SOFTWARE RELEASE NOTES

VERSION: 1.9.0

1.9.0 is a new software release for Teal 2. This update is for the AV only; it is not for the GCS.

1. Calibration sides for the compass

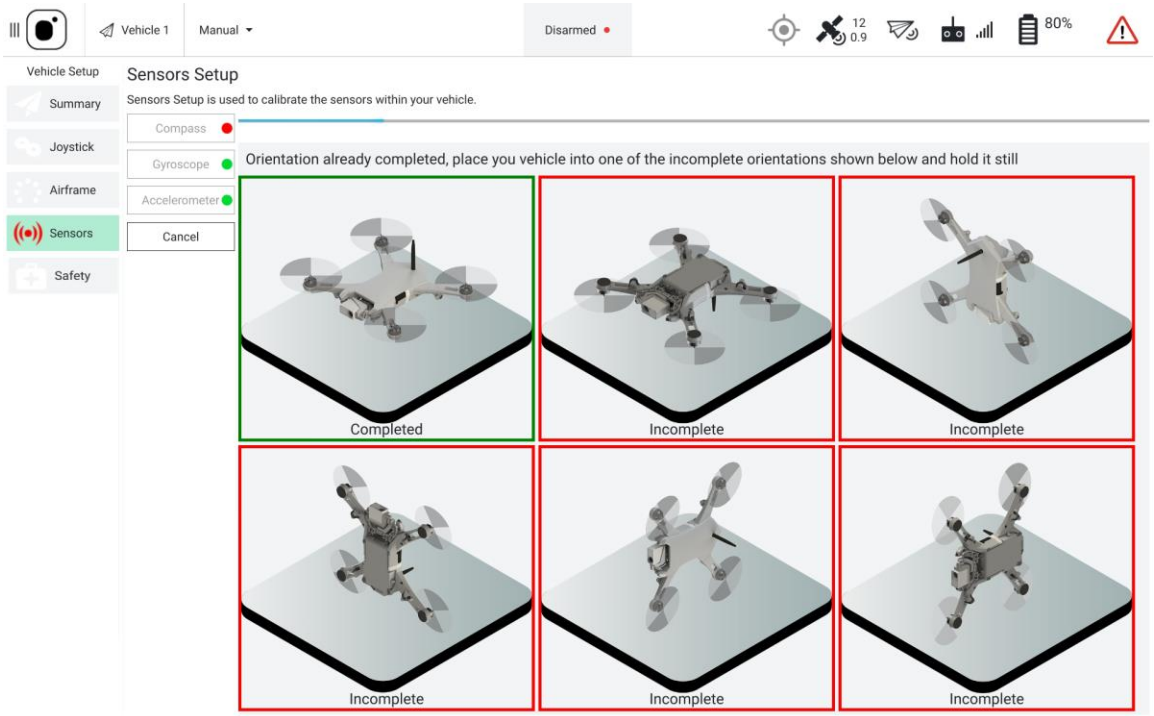
Now, there are six sides to calibrate the compass and accelerometer. The gyroscope has one side to calibrate.
